**Thompson Falls Hydroelectric Project  
FERC Project No. 1869**

**NorthWestern Energy  
Initial Study Report  
Hydraulic Conditions Study**

April 2022

**Figure 3-16. Run 3: 2,000 cfs Upstream Fish Passage Facility Entrance Details**

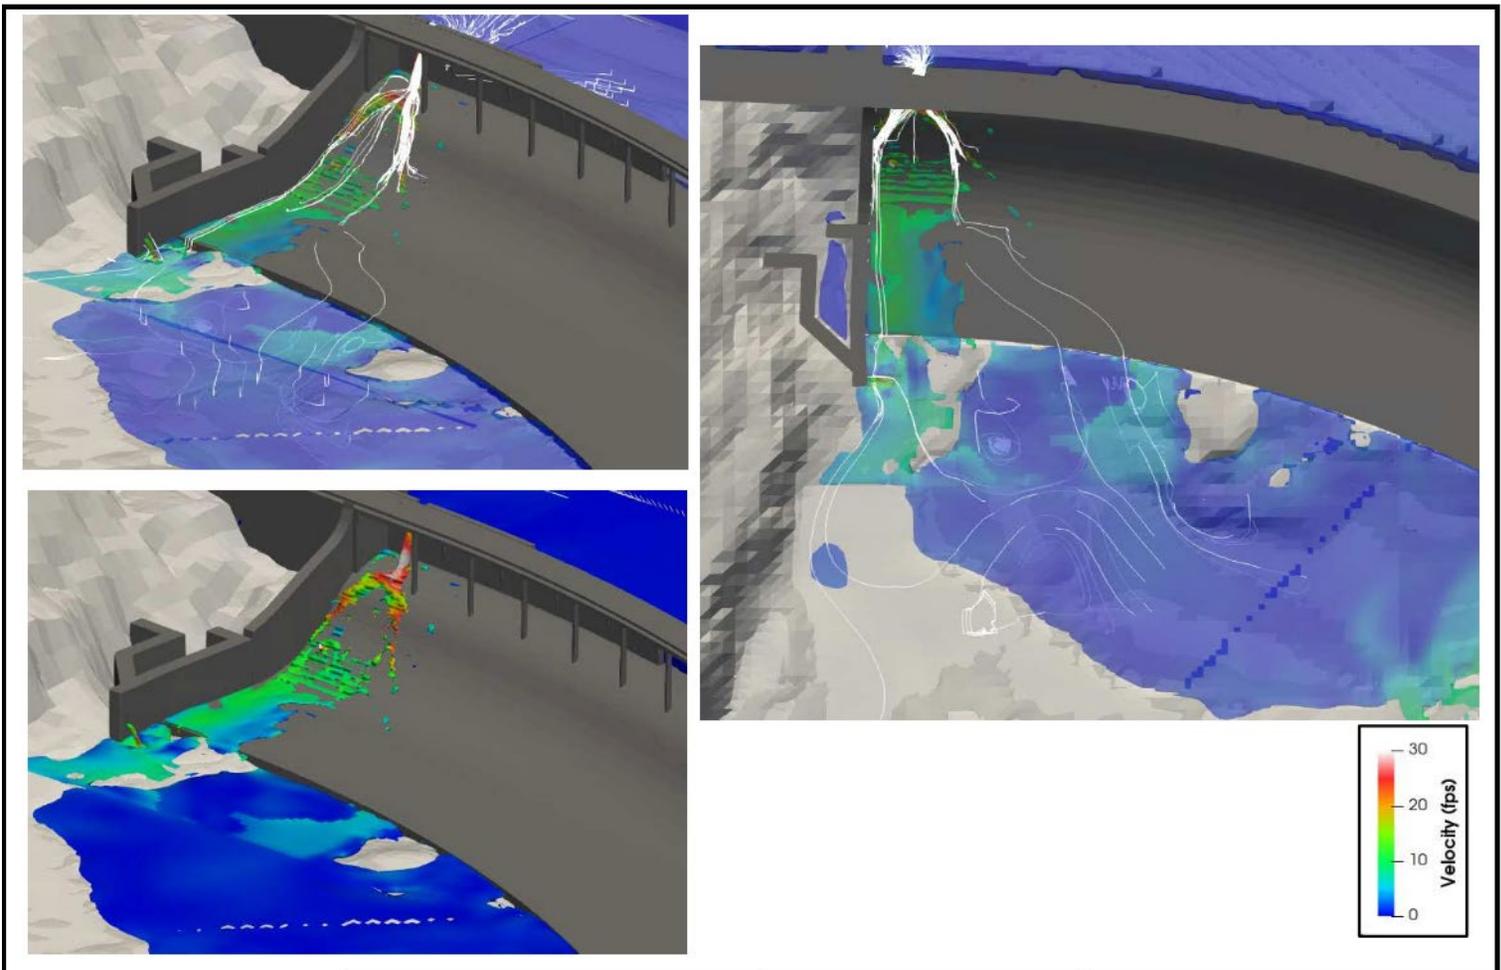
• Page 25 - Show velocity vectors when displaying velocities	33
• Page 36, Figure 3-16 discussion: This is the first really meaningful relevant observation from the model runs and is good; How does this compare with measurements?	34
